FINAL SUBDIVISION PLAN AND LAND DEVELOPMENT PLAN

**RE: Waiver Request**  
Subdivision Plan  
**Akbar & Susan Boutorabi**  
583 Trail Road North  
Mount Joy Township  
Lancaster County, PA

Re: Akbar & Susan Boutorabi Final Subdivision Plan and Land Development Plan  
Our File No. 10221-1

Re: 583 Trail Road North (Boutorabi)  
Final Subdivision and Land Development Plan  
Township Permit No. 2026-03-FSDP  
LCEC Project No: 25-211

DRAWN BY: JHP CHECKED BY: GRK
<b>SUBDIVISION PLAN</b>	
PROJECT: SUBDIVISION PLAN Owner: Akbar Boutorabi 583 TRAIL ROAD NORTH LANCASTER COUNTY, PENNSYLVANIA	
TITLE:	
PROJECT No: 250610	
SCALE: (H) 1"=50' (V) N/A	
DATE: 2025.06.10	
SHEET No: 3 OF 9	
REV No:

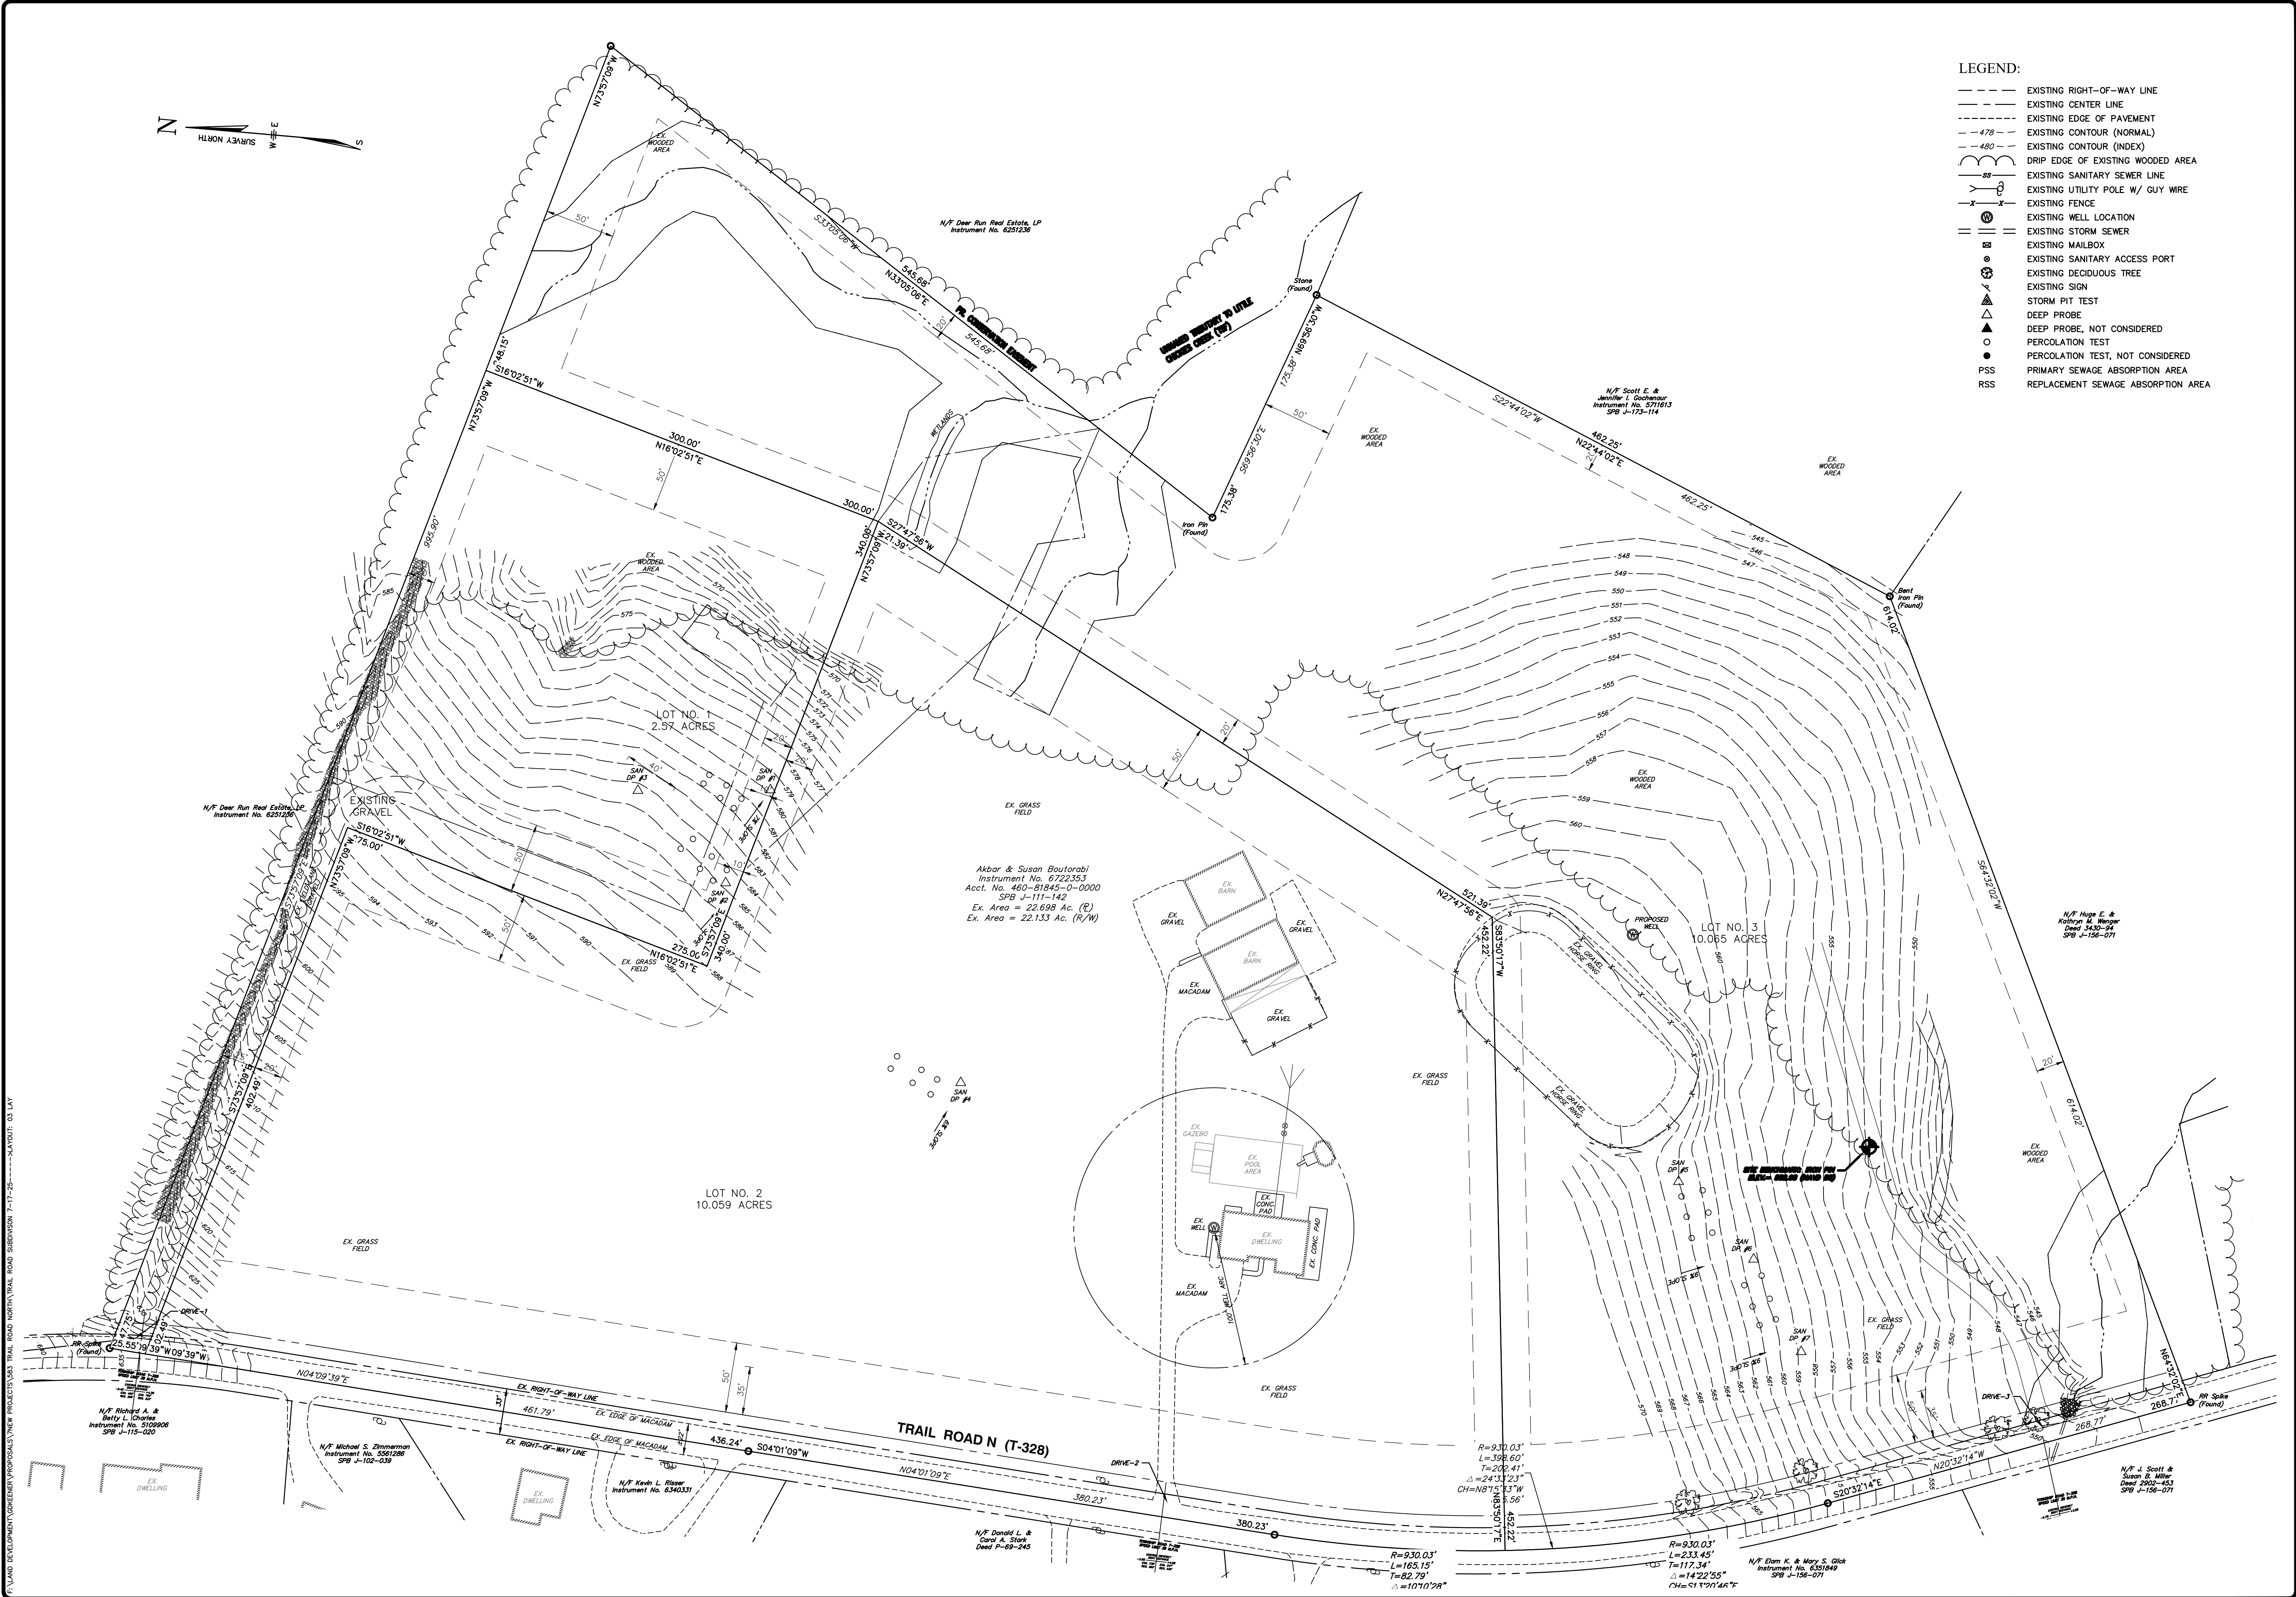
4. Exercise pens shall be located at least 30 feet from any property line (135-302.A). The proposed lot line does not meet this requirement with respect to the existing gravel horse ring.

5. Any barn shall be located 100 feet from any lot line (135-302.C(1)). The proposed lot line does not meet this requirement.
6. Slopes greater than 15% shall be shown on the plans (135-305.A). A differentiation of slopes between 15% and 25% and those greater than 25% shall be indicated on the plans.

8. The cartway within the flag pole shall be located at least six feet from any adjoining property line (135-320.F(4)).
9. The cover sheet shall provide the calculations for determining the required off-street parking spaces (135-343.C).

26. The front setback for Lot No. 1 shall be 35' for single-family detached dwellings (119-31.D(5)).
27. The gross and net lot areas shown in the Site Data table are inconsistent with the gross and net lot areas shown on the plan views (119-31.D(9)).

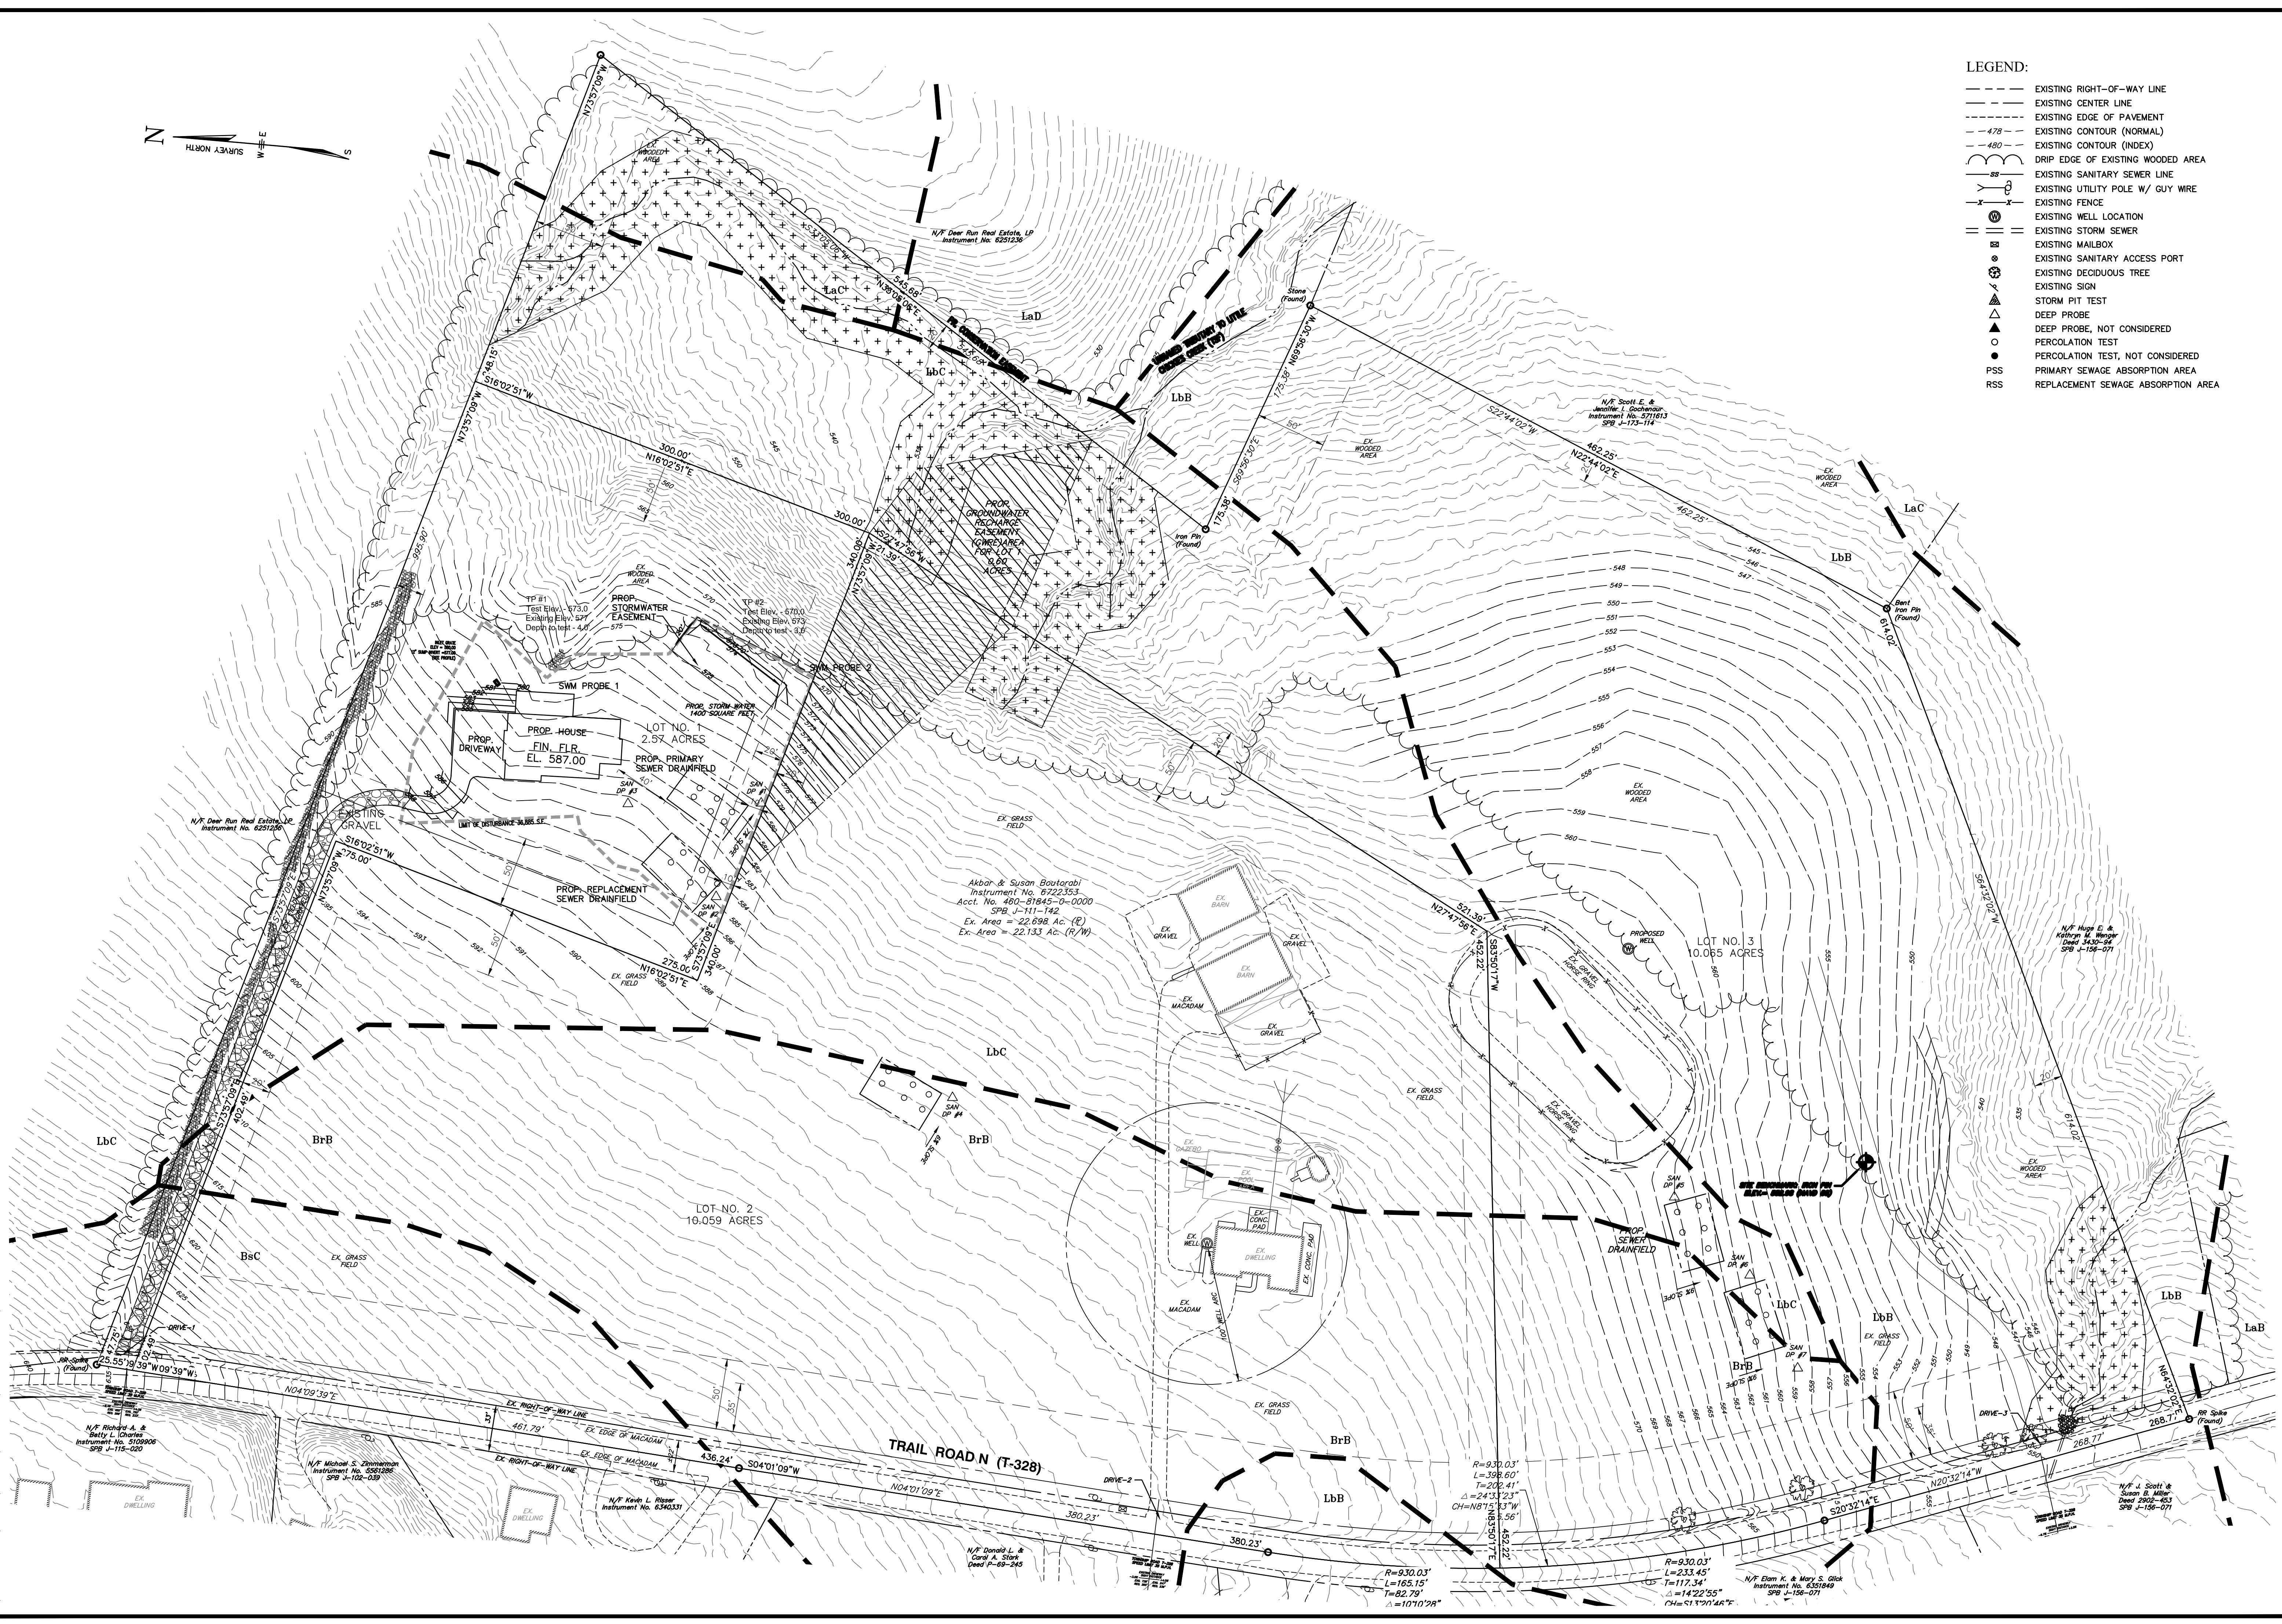
30. A wetlands study shall be provided (119-32.B & 119-34.E(3)(c)).
31. The proposed 572 contour near the southeastern edge of the infiltration bed shall be revised (119-35.D(5)).

56. When located under vegetative cover, the top of a subsurface facility shall be a minimum of 12 inches below the surface elevation (113-37.B(4)(b)). The proposed grading on the eastern side of the proposed infiltration bed does not provide one foot of cover.

58. The proposed layout shows a single roof leader from the proposed dwelling. The engineer shall clarify whether the dwelling is served by a single downspout or revise the plans to show all roof leader connections and routing. (113-37.C).

64. Spot elevations shall be added near the proposed inlet to ensure that overland drainage from the driveway and grass is captured by the inlet (113-43.J(1)).

65. A profile of the proposed stormwater conveyance pipe between the inlet and infiltration bed shall be added to the plans (113-43.J.(5)).
66. The dimensions of the infiltration bed shown on the plans are inconsistent with the length and width dimensions shown in the construction detail (113-43.J(5)).
